# CITY OF ALBUQUERQUE

RE: **Lot 12P1 Block 8B S.A.D. 227 Unit 3**  
**6401 Little Joe Dr. NW**  
**Grading and Drainage Plan**  
**Engineers Stamp Date 8/13/2020 (E10D083)**

ENGINEER'S SEAL  DAVID SOULE NEW MEXICO REGISTERED PROFESSIONAL ENGINEER 14522  8/13/20  DAVID SOULE P.E. #14522	6401 LITTLE JOE PLACE  GRADING AND DRAINAGE PLAN   <i>Rio Grande Engineering</i> 1608 CENTRAL AVENUE SE SUITE 201 ALBUQUERQUE, NM 87106 (505) 972-0899	DRAWN BY DEM
		DATE 8-13-20
	SHEET #  C1	6401 LITTLE JOE PL.DWG
		JOB #

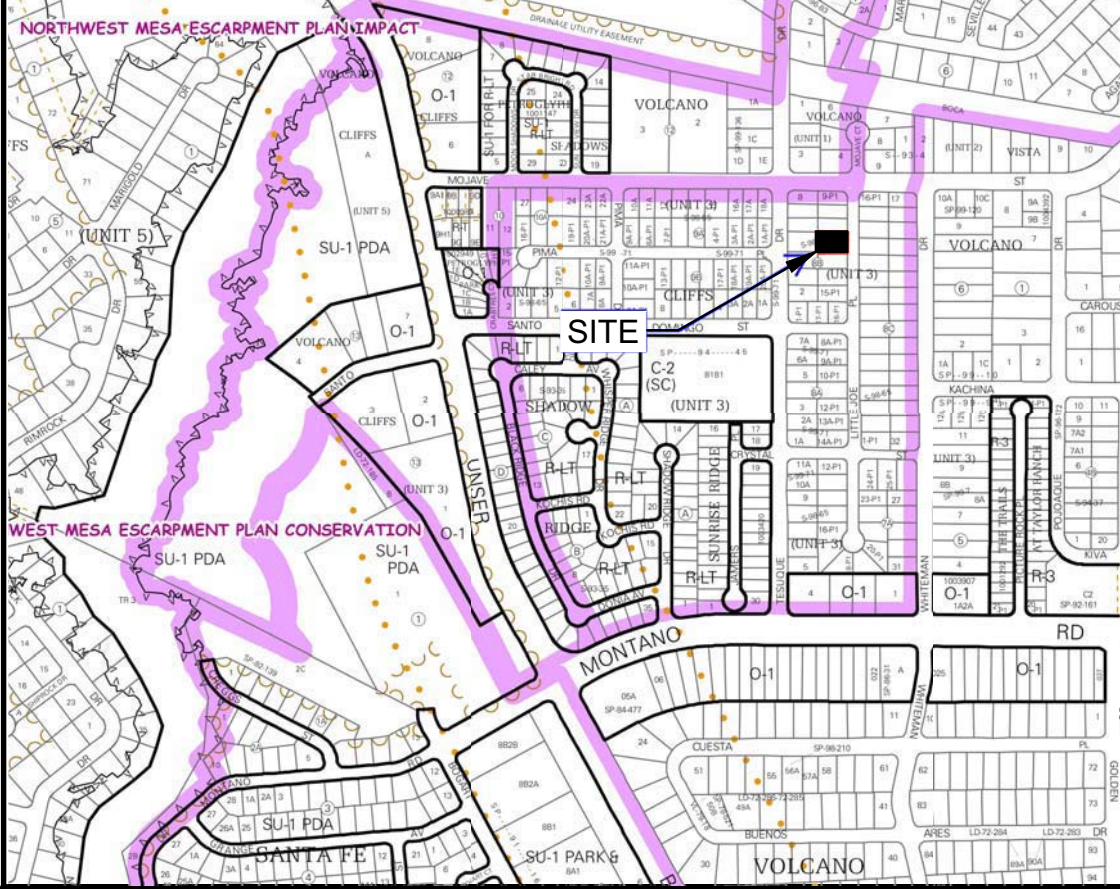
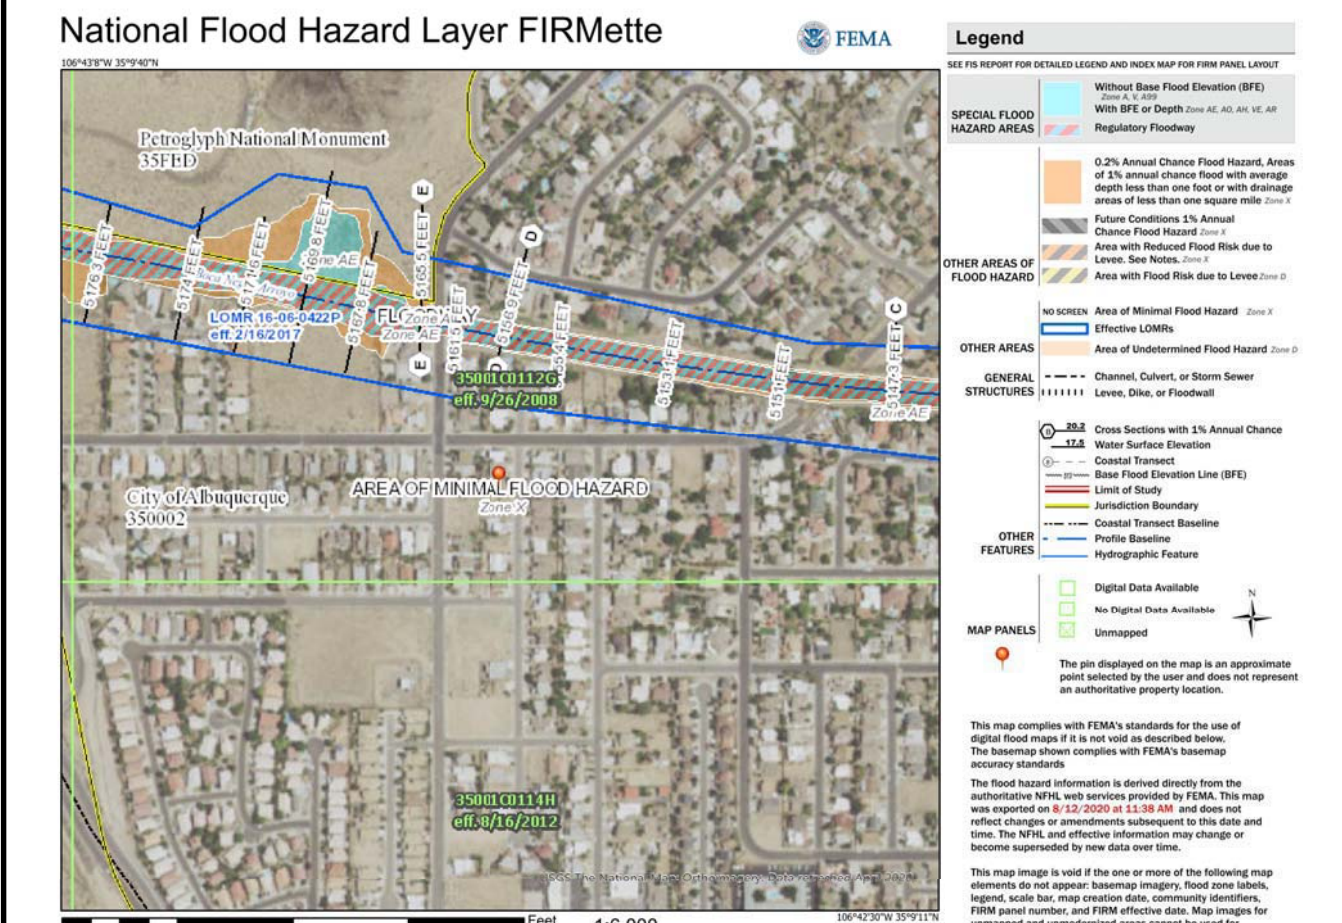
Based upon the information provided in your submittal received 8/14/2020, this plan is approved for Grading Permit. Please inform the builder/owner to attach a copy of this approved plan and letter into the construction sets in the permitting process prior to sign-off by Hydrology.

**Reiterate to the Owner/Contractor that a separate permit for any garden/retaining wall must be obtained, with the approved G&D plan.**

Prior to Building Permit approval, a **Pad Certification** will be required. Inform the contractor/owner not to pile dirt in the street as a ramp to climb the curb. If dirt is found in the street the pad cert. will be denied.

Prior to **Certificate of Occupancy release**, Engineer Certification per the DPM checklist of this plan will be required.
